## **ADDENDUM #2**

### **11/8/2023**

PROJECT NAME:  
WCU KILLIAN BUILDING  
HVAC UPGRADES AND  
WINDOW REPLACEMENT  
(PHASE 1)

DRAWING NUMBER:  
A002

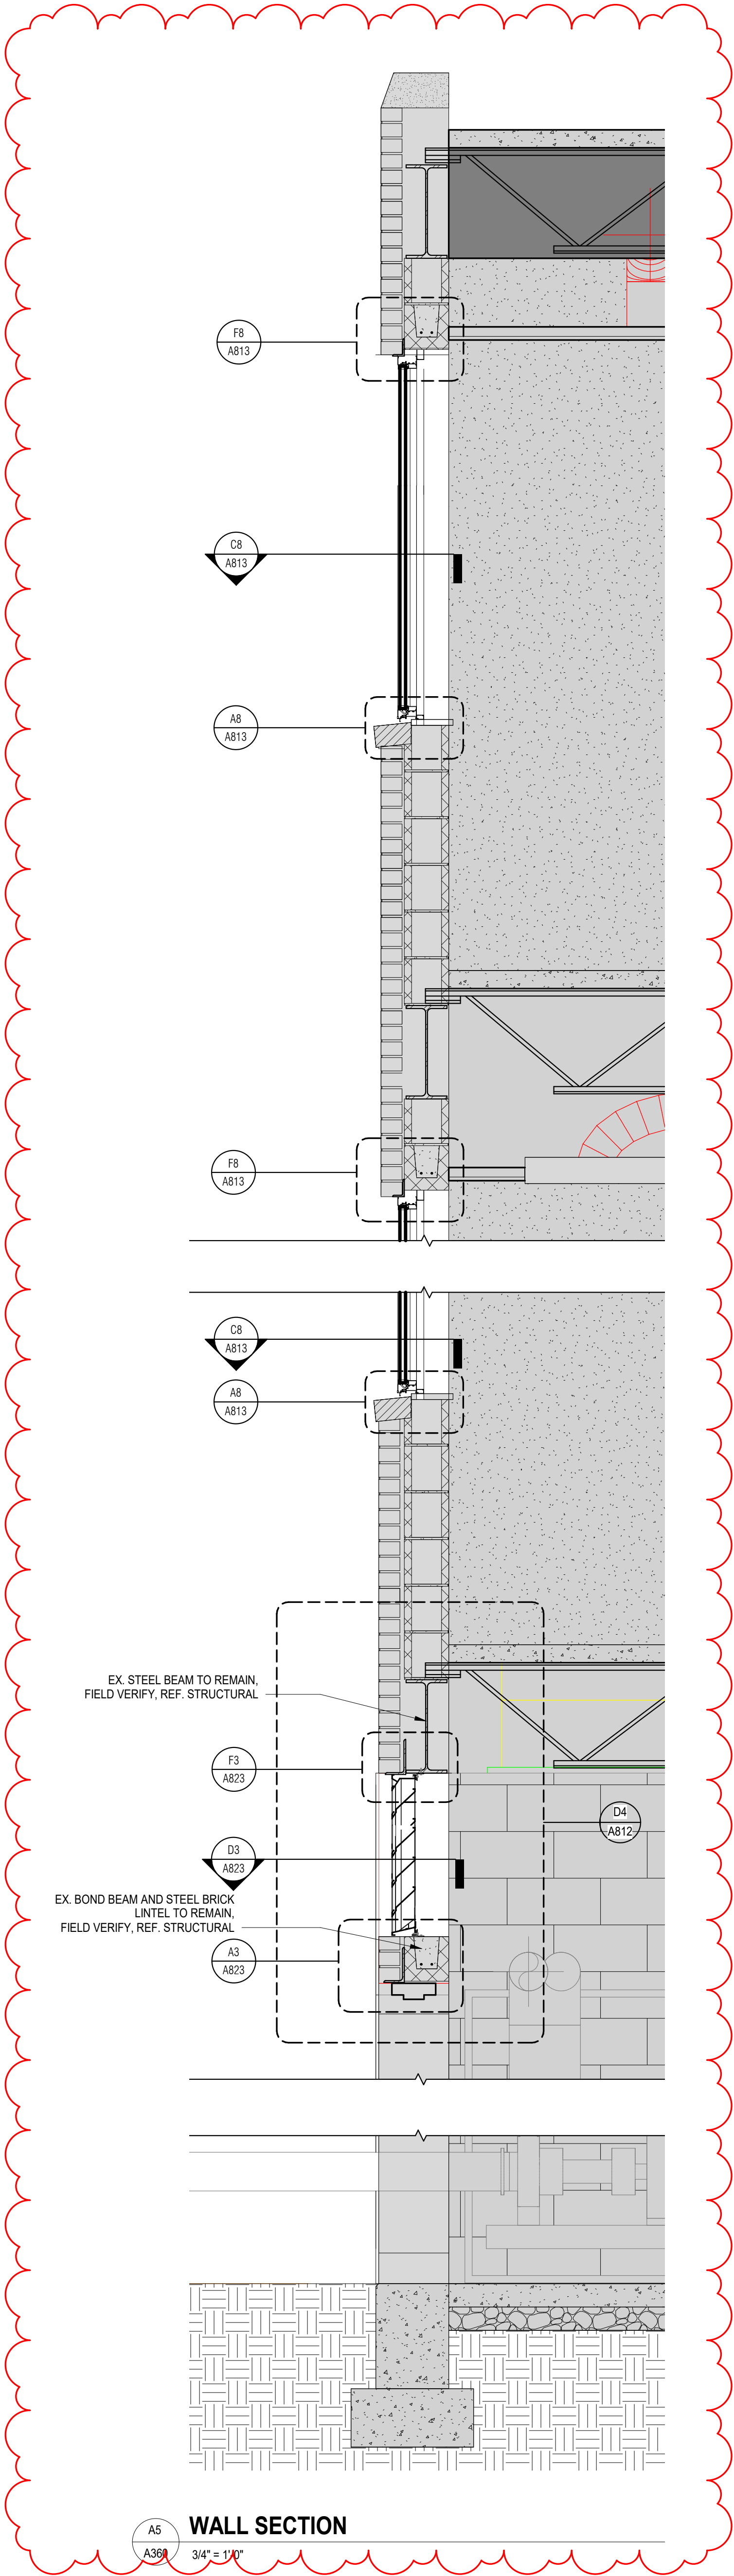
1. Drawing A002:
  - a. Added note to the drawing.
2. Drawing A360:
  - a. Revised wall section.
3. Drawing A813:
  - a. Revised window head, jamb & sill details.
4. Drawing A822:
  - a. Revised louver head, jamb & sill details.
5. Drawing A823:
  - a. Revised louver head, jamb & sill details.

DRAWING NUMBER:  
**A360**

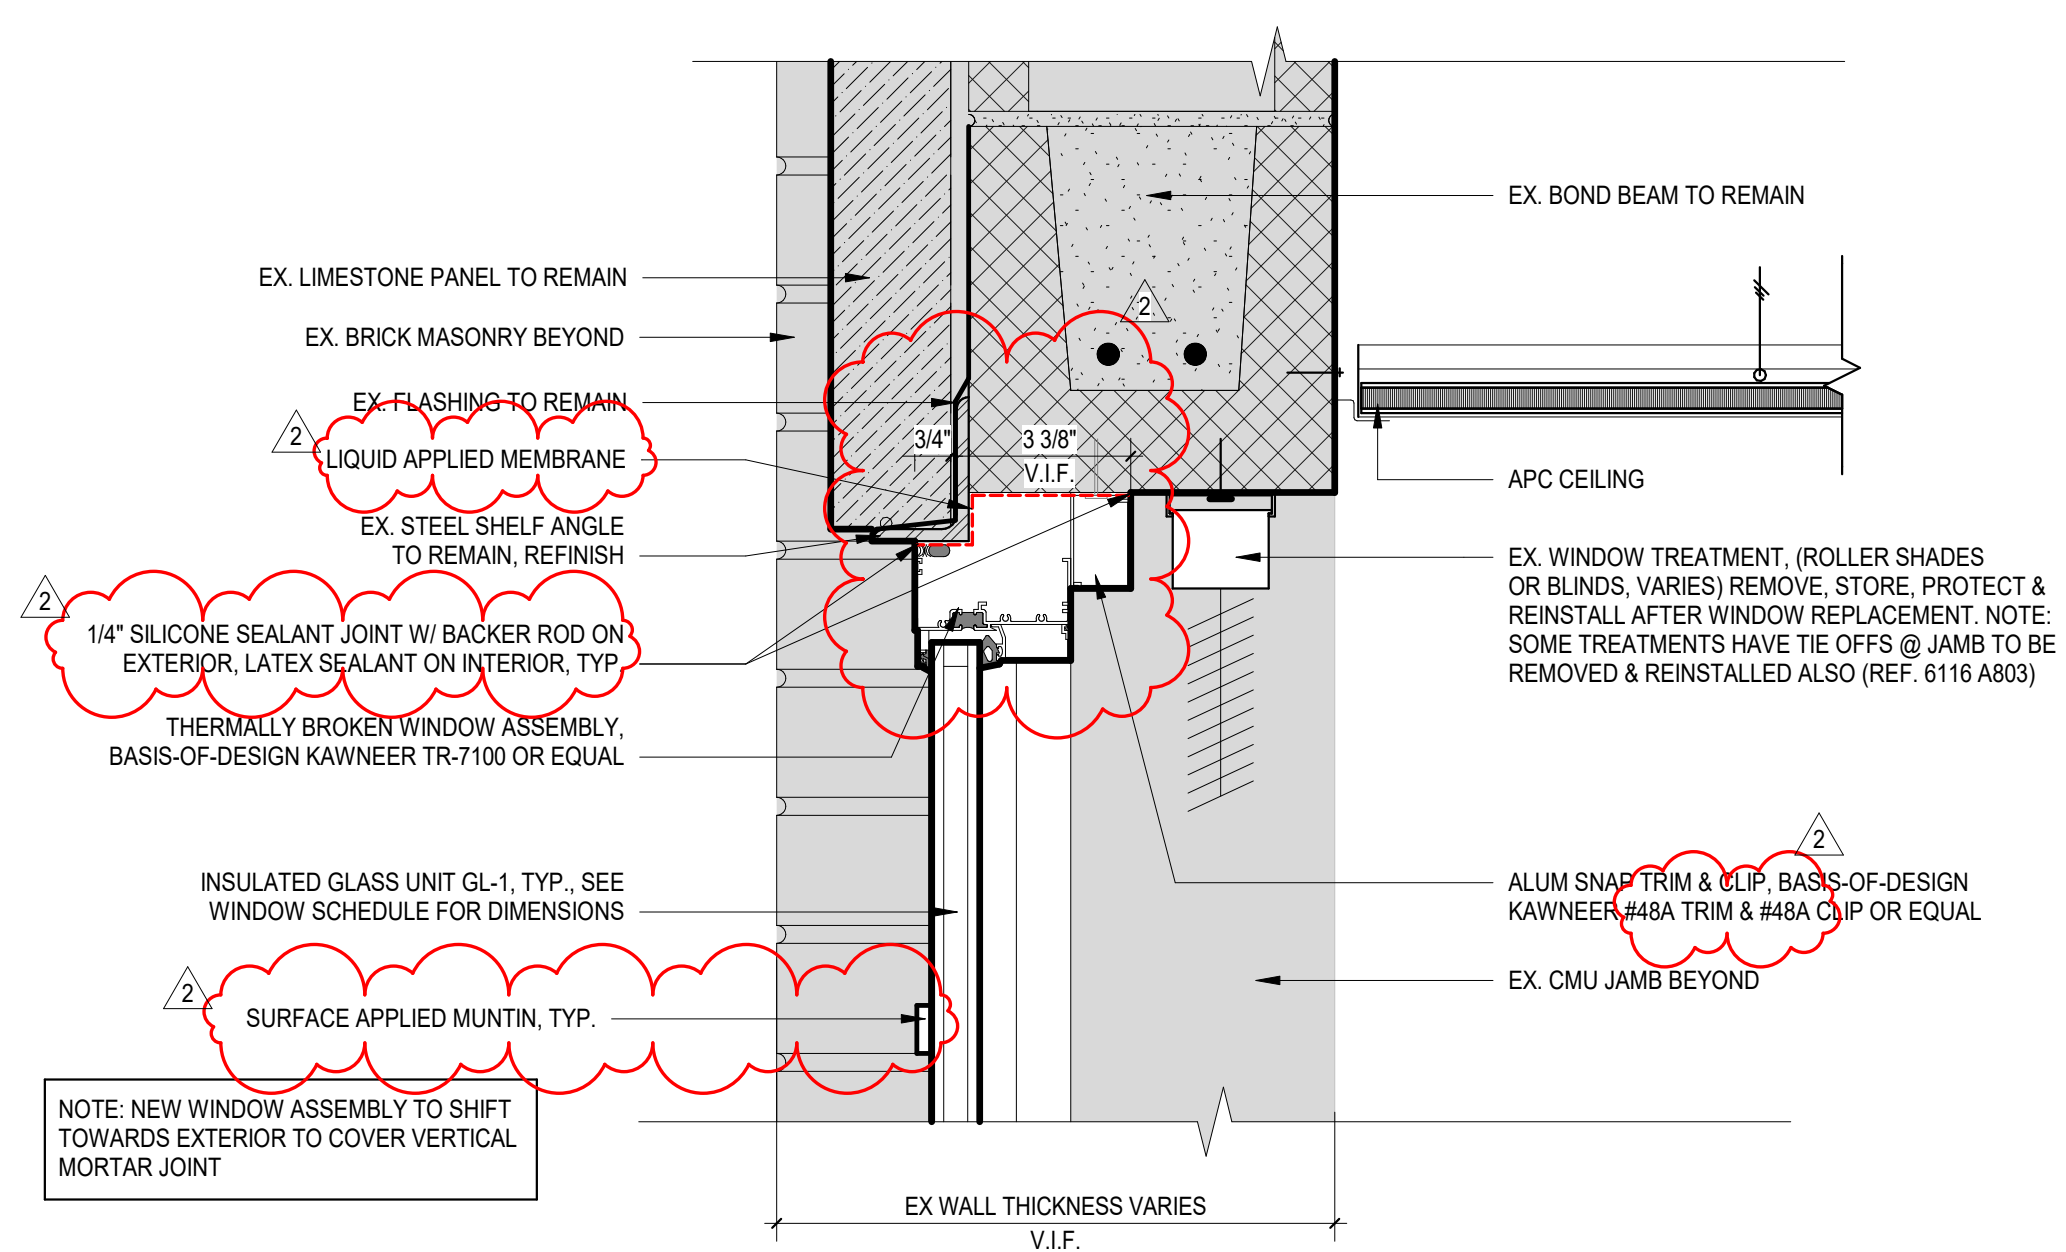
- 18. Sheet A360 – Recommend illustration of full height section to clarify design intent.

**MPS Response: Included/Revised.**

F6 WINDOW HEAD DETAIL AT LIMESTONE PANEL  
A813 3" = 1'-0"

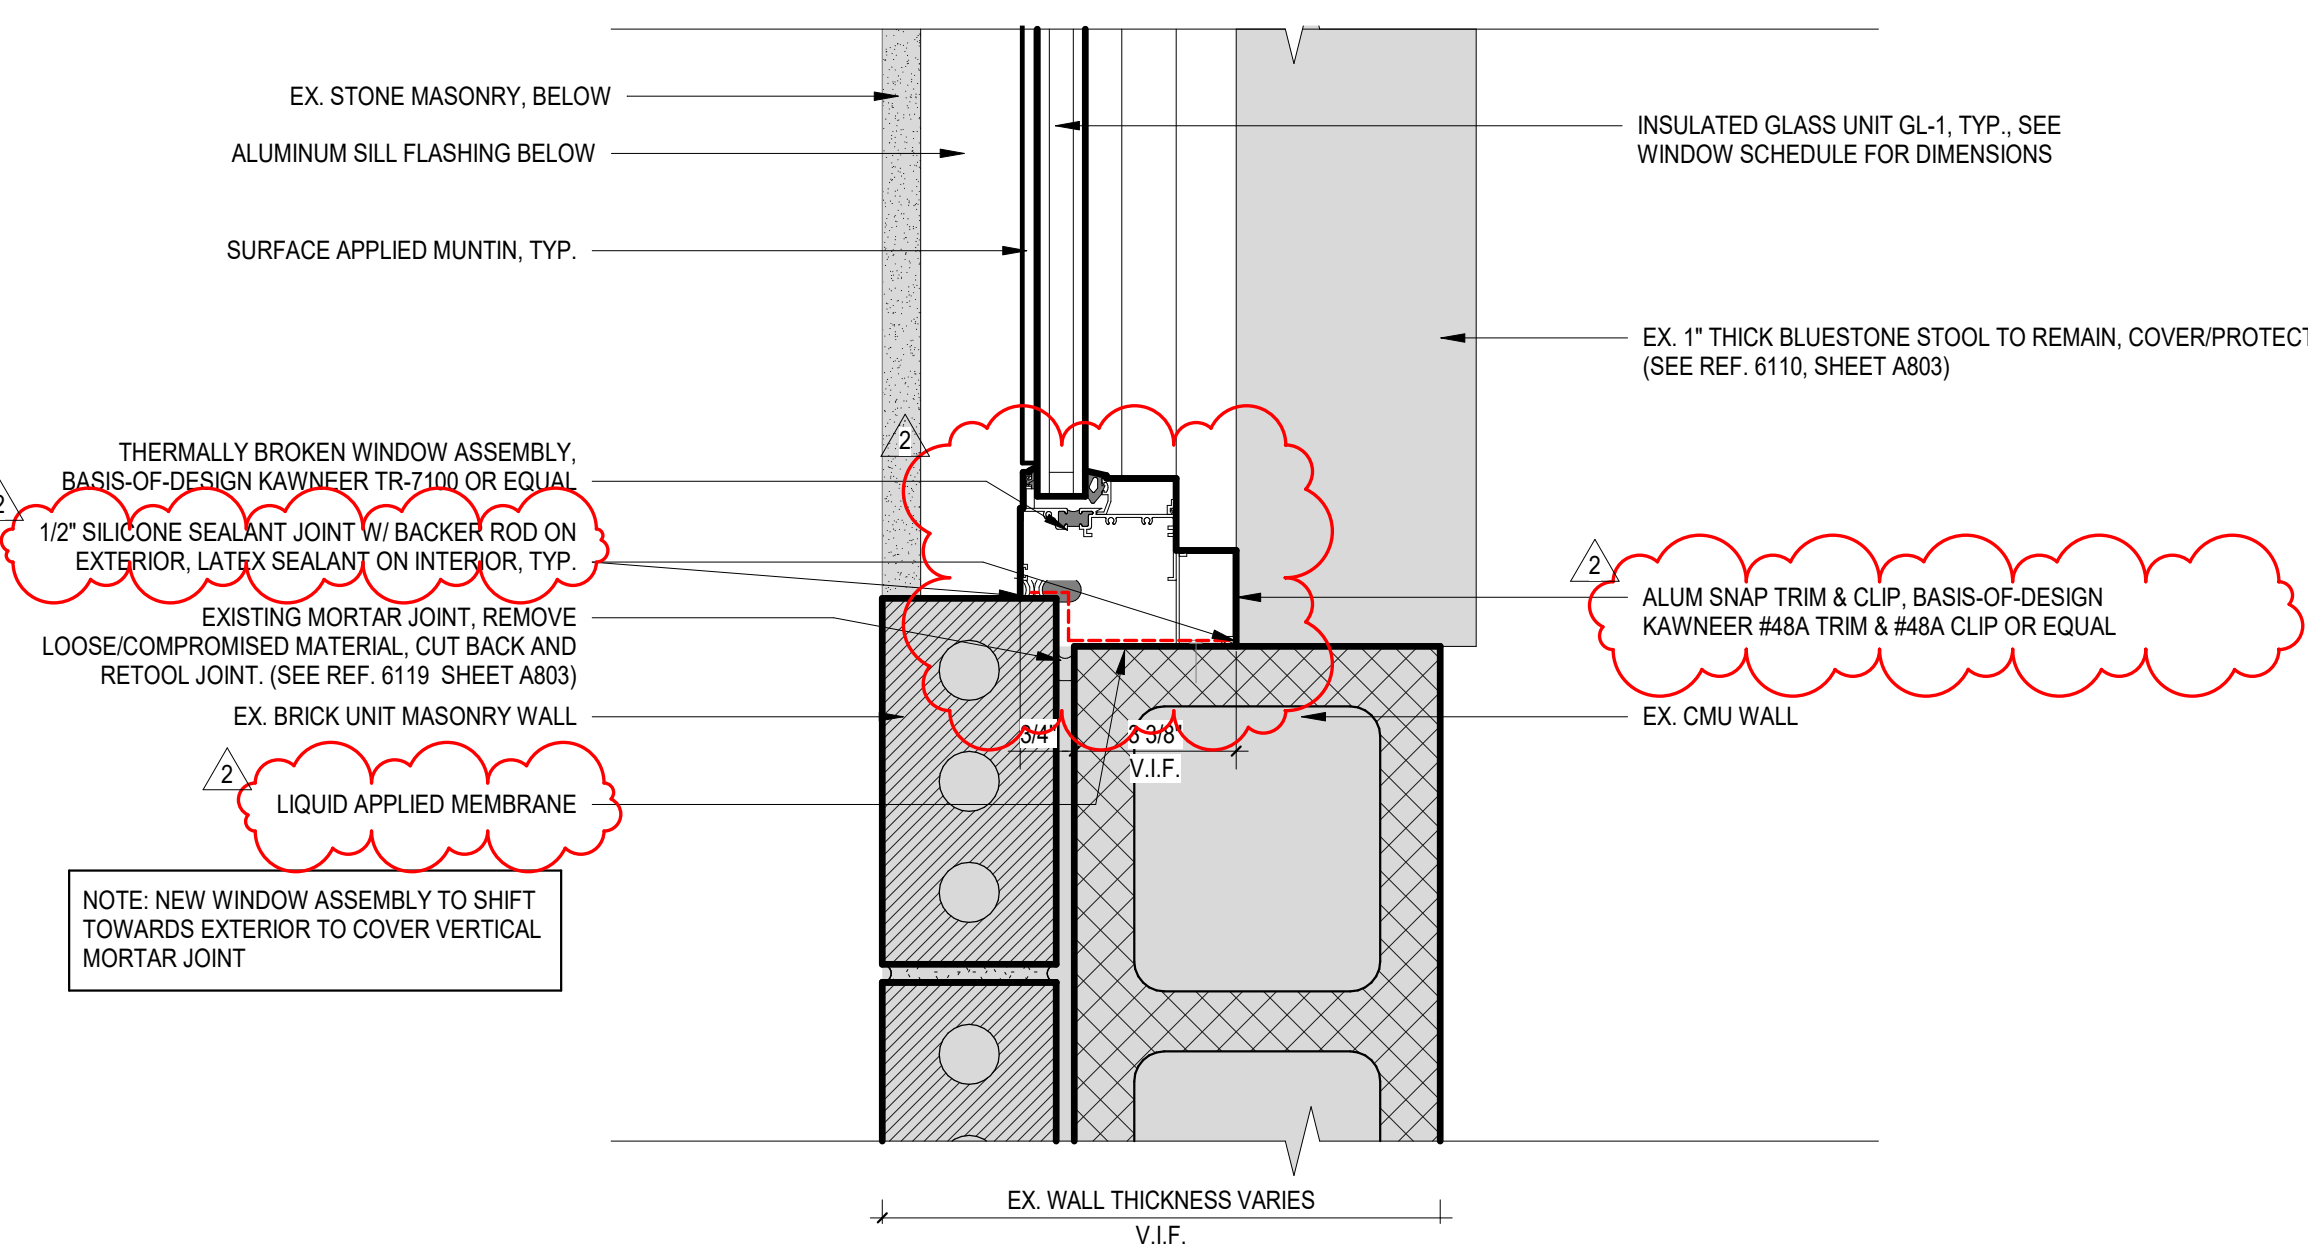
d. Detail F8

MPS Response: **Accepted**.

MPS Response: **Included/revised with modifications** – self adhered membrane added.

MPS Response: **Rejected** - Existing flashing to remain, no problems reported at this time.

C6 WINDOW JAMB DETAIL AT LIMESTONE PANEL  
A813 3" = 1'-0"

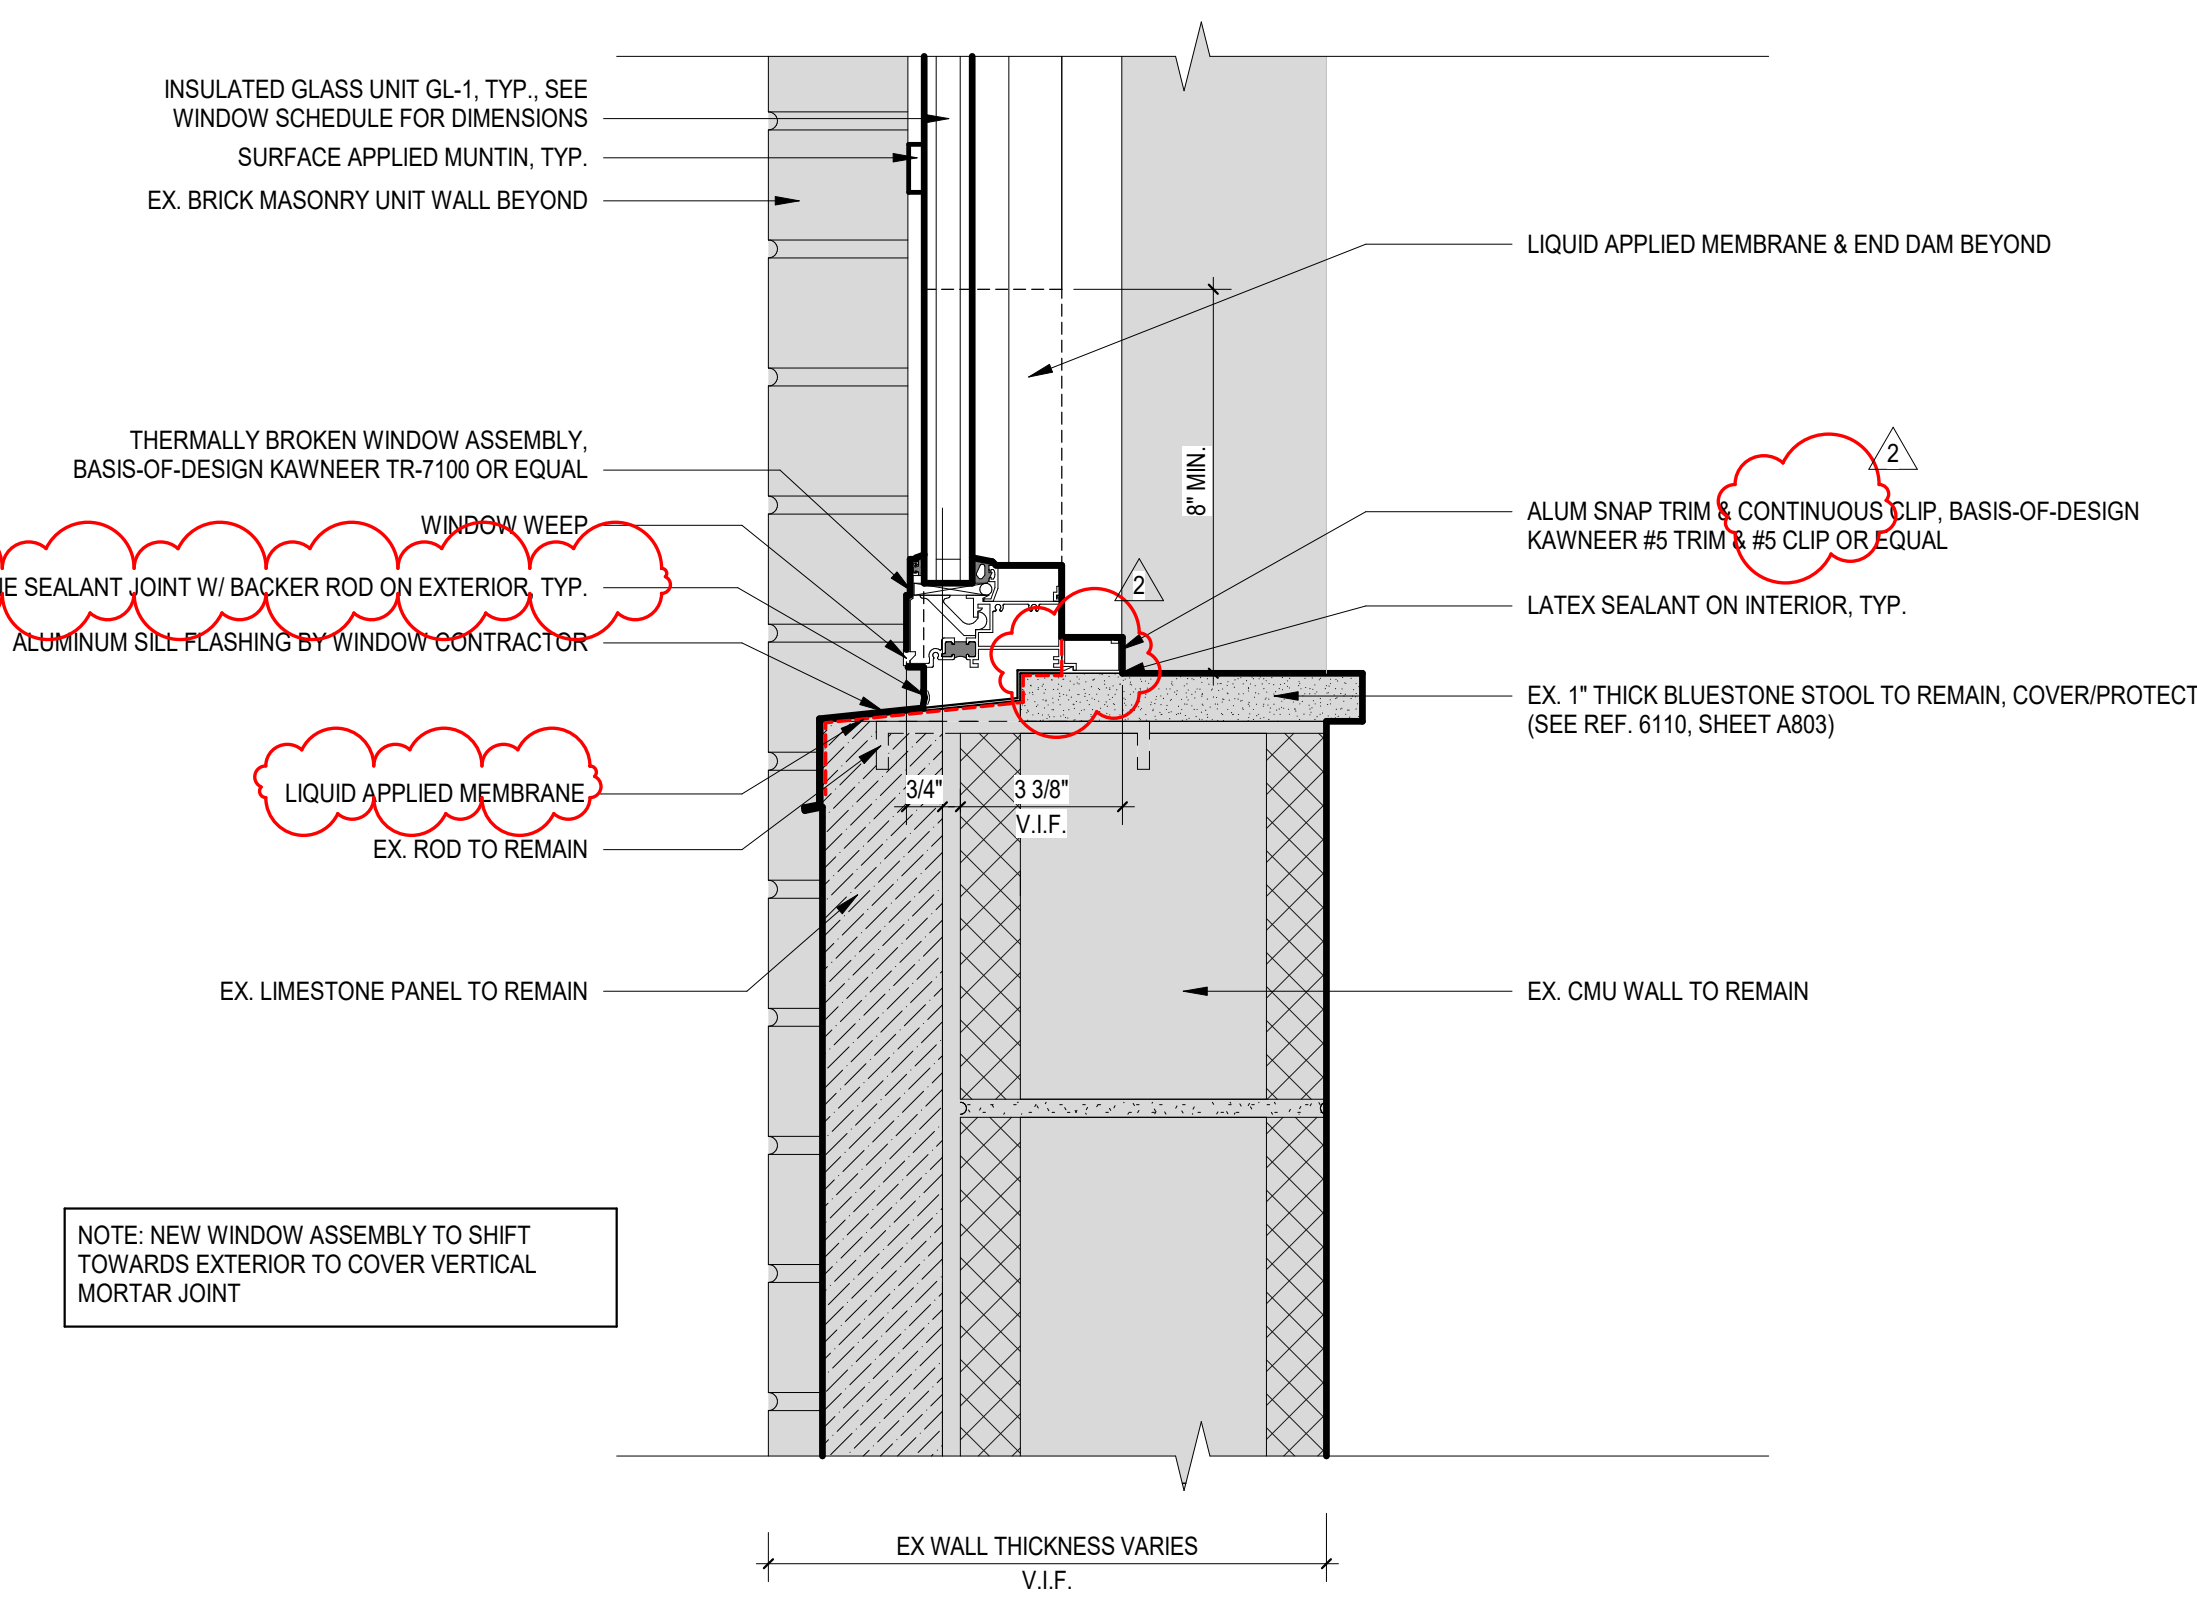
c. Detail C8

MPS Response: **Accepted**.

MPS Response: **Included/Revised**.

MPS Response: **Rejected** – basis of design unit is already thermally broken and we are unsure if manufacturer would even allow this modification.

MPS Response: **Included/Revised** – cavities to be filled.
